October 9, 1992

Subject: Generic Letter 90-06, "Resolution of Generic Issue 70, 'Power-operated Relief Valve and Block Valve Reliability,' and Generic Issue 94, 'Additional Low-Temperature Overpressure Protection for Light Water Reactors.'"

Byron Station Units 1 and 2, NRC Docket Numbers 50-454/455,
Braidwood Station Units 1 and 2, NRC Docket Numbers 50-456/457,
Zion Station Units 1 and 2, NRC Docket Numbers 50-295/304.

BYRON AND BRAIDWOOD STATION SYSTEM CONFIGURATION

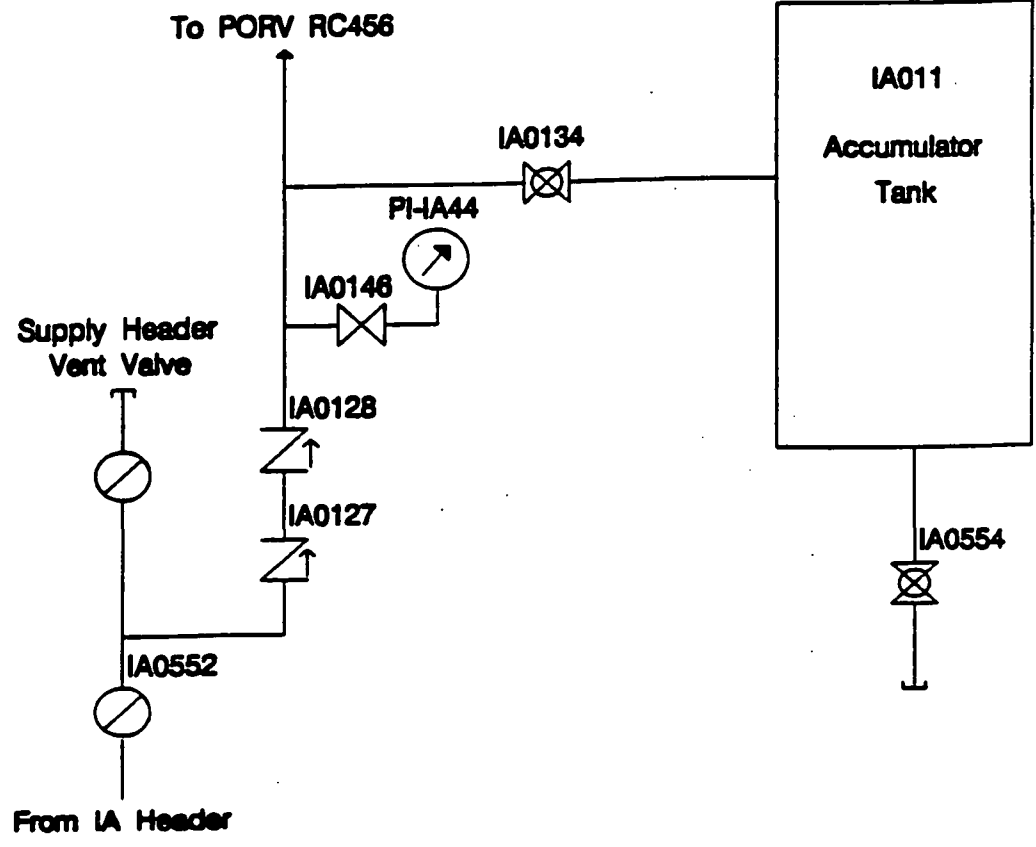
At Byron, Braidwood, and Zion, instrument air is the normal air supply source and an air accumulator is the safety backup supply source. At Byron and Braidwood the normal flow path of instrument air to the PORV control air valves passes through the safety backup air accumulator. Therefore, the flow to the control air valves must go through the safety backup accumulator regardless of whether the operating air supply is from the normal source (instrument air) or from the backup air supply (air accumulator). At Zion, the instrument air does not pass through the accumulator. There is one isolation valve between the accumulator and the instrument air header which remains open. Therefore, the same flow path to the control valves is utilized regardless of whether the operating air is from the normal source or backup air supply. Two attachments are enclosed; one for the Byron and Braidwood system configurations and one for the Zion system configuration.

The IST program PORV stroke test is performed by using the normal air supply path. The test also verifies that the air check valves that isolate the safety backup accumulator in the event of a loss of normal air supply will open. In addition, a pressure decay test is performed to verify that the check valves will close and that the valves are leak tight. In this test, the normal air supply is interrupted using an isolation valve upstream of the pressure regulator valve, and the safety backup accumulator is then monitored for any drop in pressure.

Therefore, Commonwealth Edison assures the capability of the safety backup supply to adequately operate the PORVs by performing the normal IST program and the testing described above at Byron, Braidwood, and Zion Stations. The design of the air supply system allows the normal and backup systems to be tested simultaneously. CECO will continue to perform these tests to satisfy the requirements of Generic Letter 90-06.
